## ANN ARBOR HISTORIC DISTRICT COMMISSION

### Staff Report

**ADDRESS:** 209 South Main, Application Number HDC 16-125

**REPORT DATE:** June 29, 2016

ITEM 2) Remove existing Sign and install New Exterior Signs.

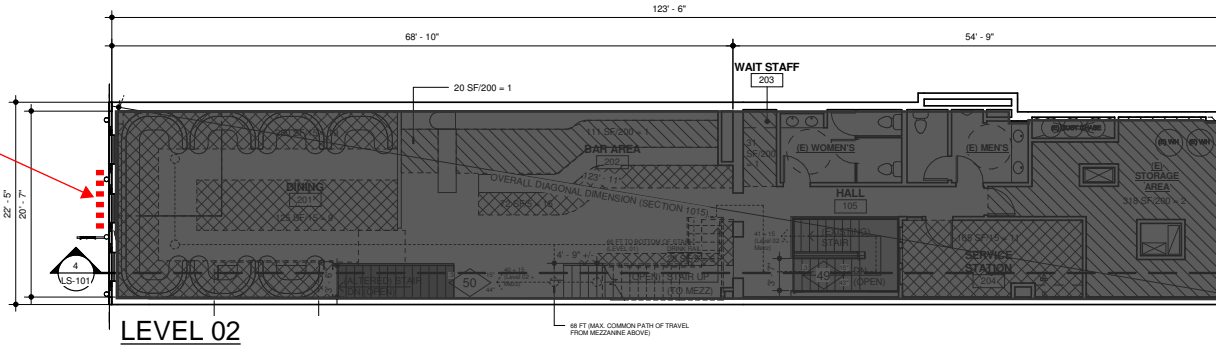
2. *Signage.* The "Jim Brady's Detroit" wall sign is white neon. The sign's size (6' x 2'3") and placement above the storefront windows are generally appropriate. The blade sign is 10' tall by 3' deep with a 6" arm attachment. The sign does not meet the *Ann Arbor Historic District Design Guidelines* for Signs. Installing a second-floor sign of this height does not align with any others along this commercial block, and is too large for a 22' wide non-corner building. In addition, the neon starburst that extends to the third floor is too large and is an architectural element of the googie style that was not historically part of this building. A smaller pedestrian-scaled sign aligned with other projecting or bracket signs on this block would be appropriate. Details on materials, construction, and method of attachment were not provided for either sign.

ITEM 1) Remove existing Storefront and Construct New Storefront.

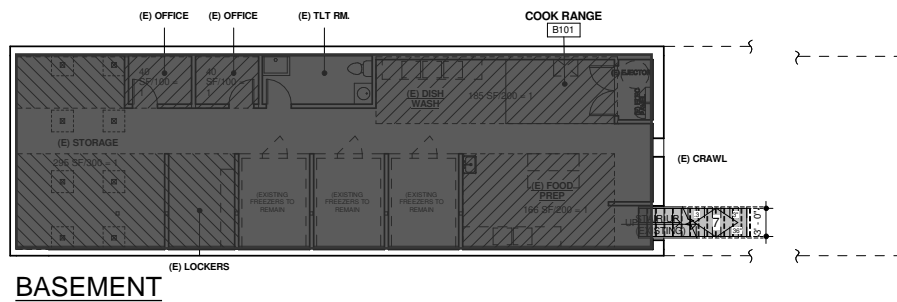
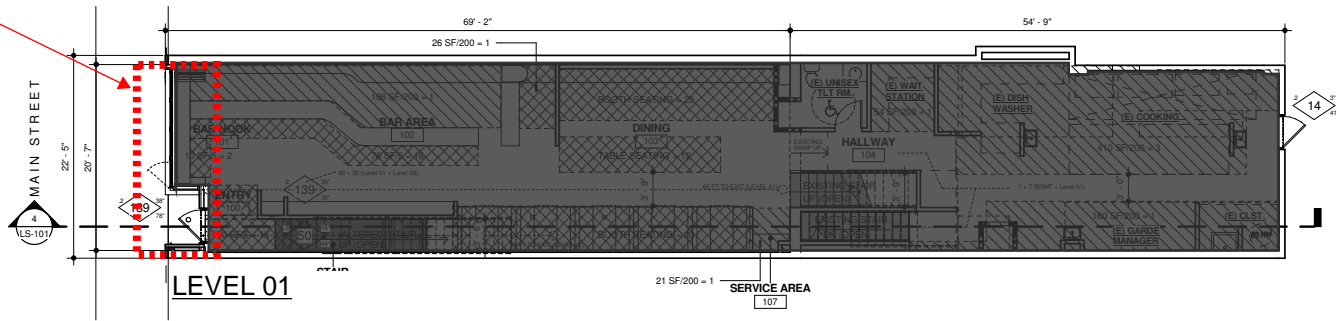
1. *Storefront.* The current storefront was installed after 1981. Per the photos at the end of this report, the 1981 storefront is or closely resembles the one from 1937. The proposed storefront is clad in black spandrel glass with a rectangular recessed entry and red tufted vinyl door with a small circular window. A four panel folding aluminum window system is to the left of the door.

The proposed storefront does not meet the Secretary of the Interior's Standard Number 3, which says that "Each property will be recognized as a physical record of its time, place, and use. Changes that create a false sense of historical development, such as adding conjectural features or elements from other historic properties, will not be undertaken." The use of glass panels as cladding and a tufted door are reminiscent of storefronts from the 1930s or 40s, an example of which still exists on the next block of South Main Street. Installing the proposed storefront today would create a false sense of historical development by imitating a style of storefront that never existing in this location.

The storefront does not meet the SOI Guidelines for Rehabilitation for Storefronts. The proposed storefront is a radical departure from the traditional proportions of the building's current and pre-1981 storefronts and is incompatible in size and material.

The storefront does not meet the Ann Arbor Historic District Design Guidelines for Storefronts. The design is new (not an accurate restoration) and the materials and design are not compatible with this historic building. The design should not introduce new reproduction architectural elements that were not historically part of this building.

The storefront does not meet the Ann Arbor Historic District Design Guidelines for Commercial Entries. The proposed red tufted vinyl door with a round porthole window is not a design that is compatible with the period of the building, which was constructed in 1868, or the period of significance for the Main Street Historic District, which ends in 1944.

ITEM 5) Install New Decorative Cornice along Existing Facade.

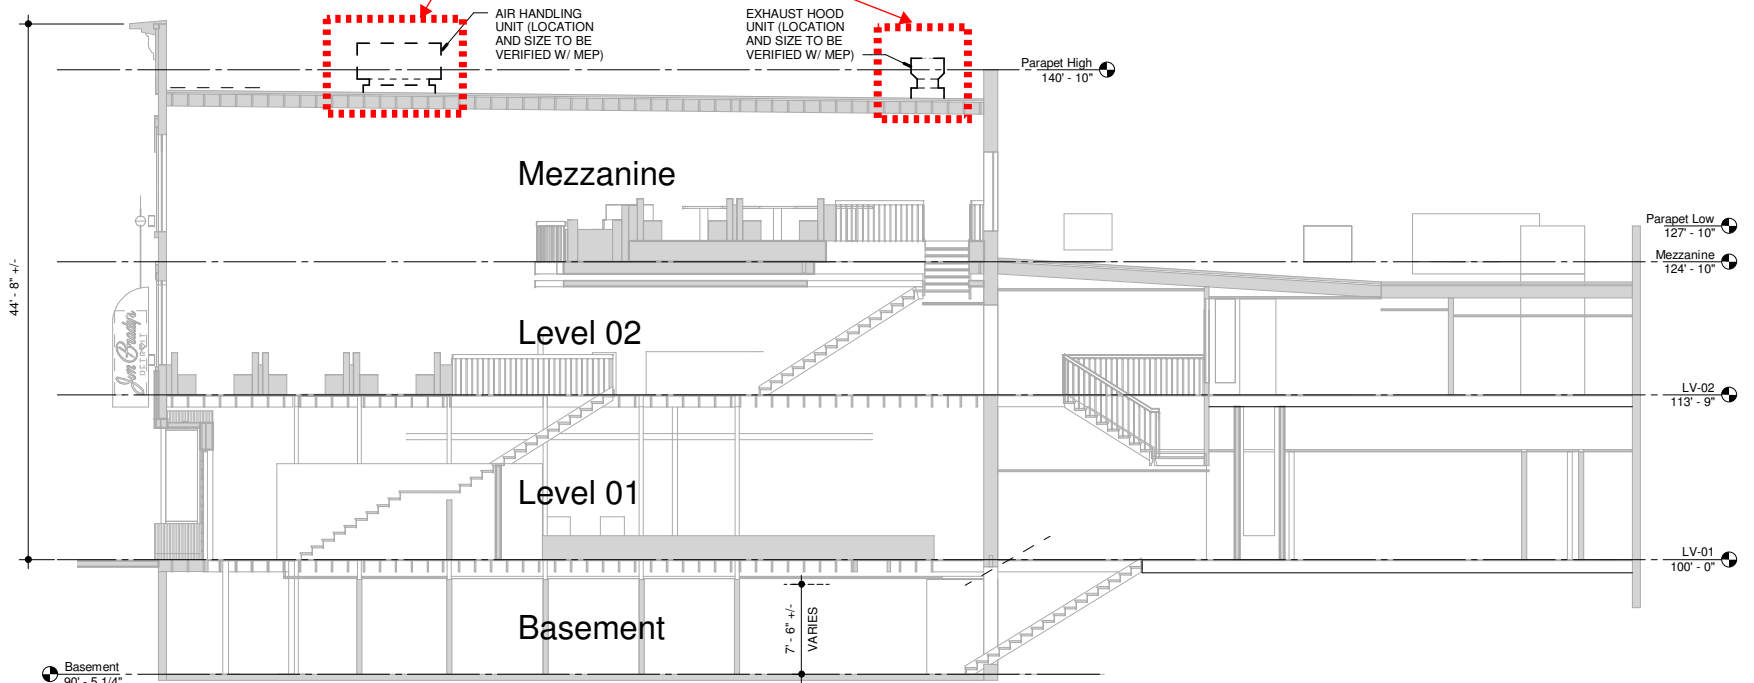
5. *Cornice.* The appearance of this building would be much more polished and formal with the reintroduction of a metal or fiberglass cornice. Photographs of the original cornice are presumed to be available from the Bentley Historical Library (an online search revealed several photos of this block), and there is a reasonable chance that the original was installed by Detroit Cornice & Slate, with plans still on file there. Rather than installing a replacement cornice of a new design, it is appropriate to find pictorial, physical, or documentary evidence of what the original cornice looked like. With this evidence, a replacement cornice may be approved at the staff level on behalf of the Historic District Commission. Therefore, staff does not recommend approval of the proposed non-historic cornice design.

ITEM 4) Install Mechanical Units on Existing Roof (and out-of-site from Main Street View) to accommodate Restaurant Modifications.

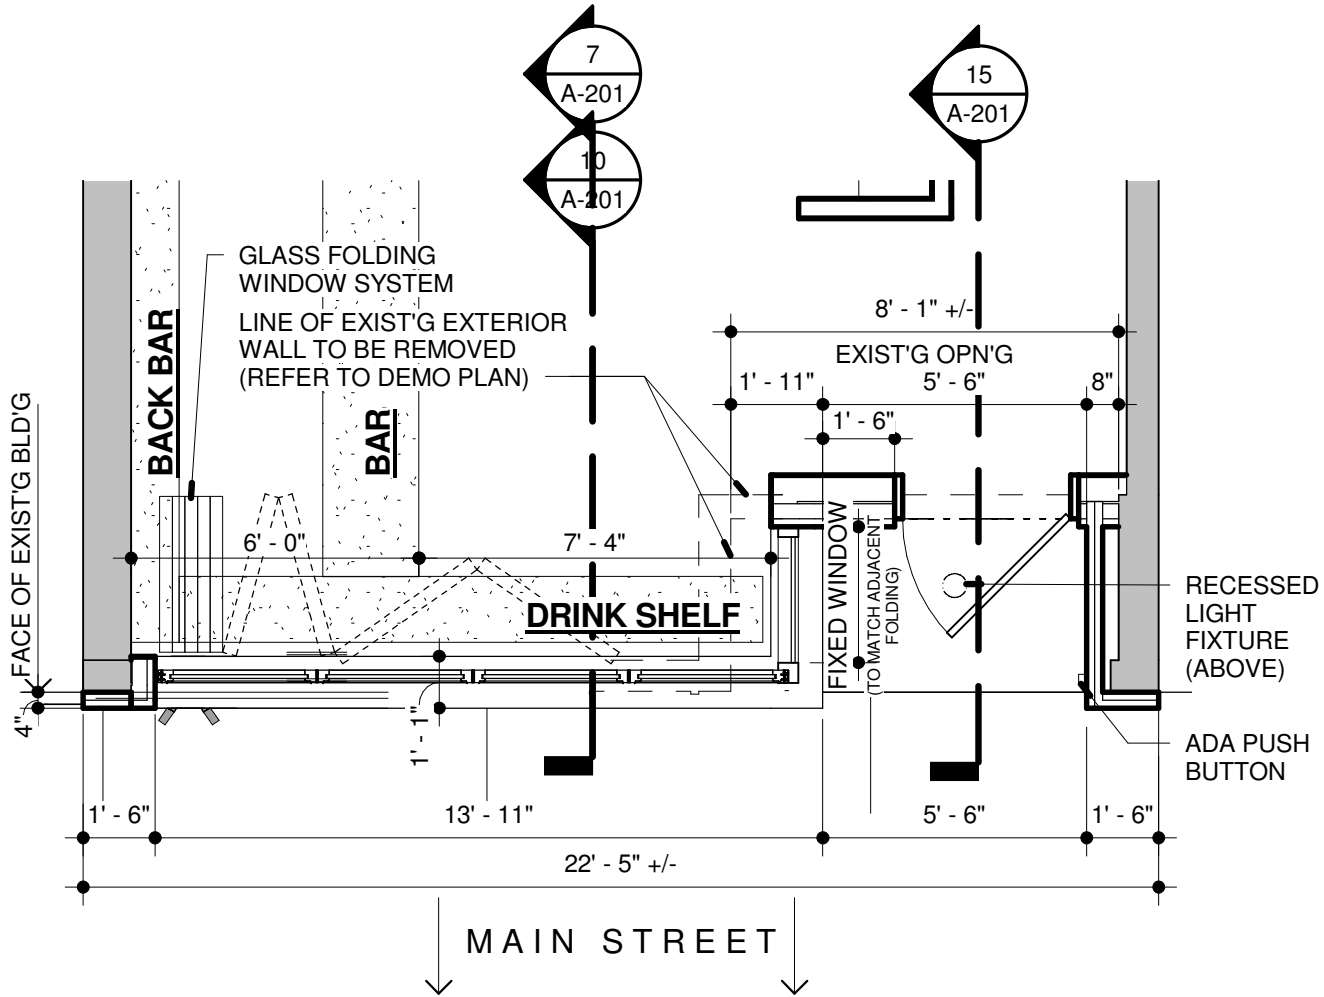
3. *Mechanical equipment.* The placement of new mechanical equipment on the roof, out of sight, is appropriate.
4. *Windows.* The third floor window work was previously approved as part of a comprehensive building renovation, and that work was begun. As long as the building owner adheres to the drawings that the Historic District Commission approved in
